# ADDENDUM NUMBER 3

Project Number STP 3374 (402), City Project 89008182

Project Title Route 45/I-29 Interchange – Phase 2C

ISSUE DATE: October 30, 2019

TYPICAL SECTION SHEET 6 OF 6

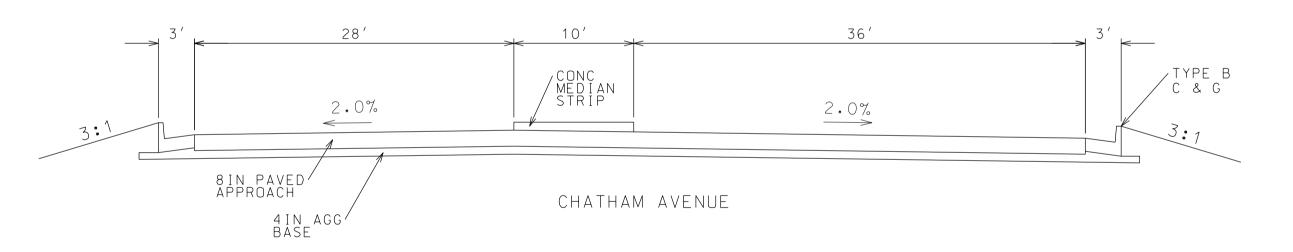
Q6.	Typical Sections Sheet 6 of 6 has been omitted from the MoDOT Plan Set. Will you be
	issuing this sheet in an addendum?
<b>A6.</b>	Yes, please see sheet 124a MoDOT Typical Sections.pdf issued with this addenda.
Q7.	Is MoDOT QC/QA required for the MoDOT part of the contract?
A7.	This contract will be let and paid for by the city of KCMO but all work on state right of
	way shall conform to all MoDOT specs.
Q8.	Specification 02102-3 Part 8 calls out for a 60 day consolidation of fills greater than six
	feet. Does this apply to this project?
A8.	This does not apply.
Q9.	Specification 02102-1 Part 2 references a waste fill on 88th Street. Again, does this
	apply to this job?
A9.	This does not apply.
Q10.	How are the 48" flared end sections to be paid for? There is not a bid item for them.
A10.	Please see new 0412 Unit Prices.pdf and 0412 Unit Prices.xls files issued with this
	addenda.

1. Please add 124a MoDOT Typical Sections.pdf to your plan set.
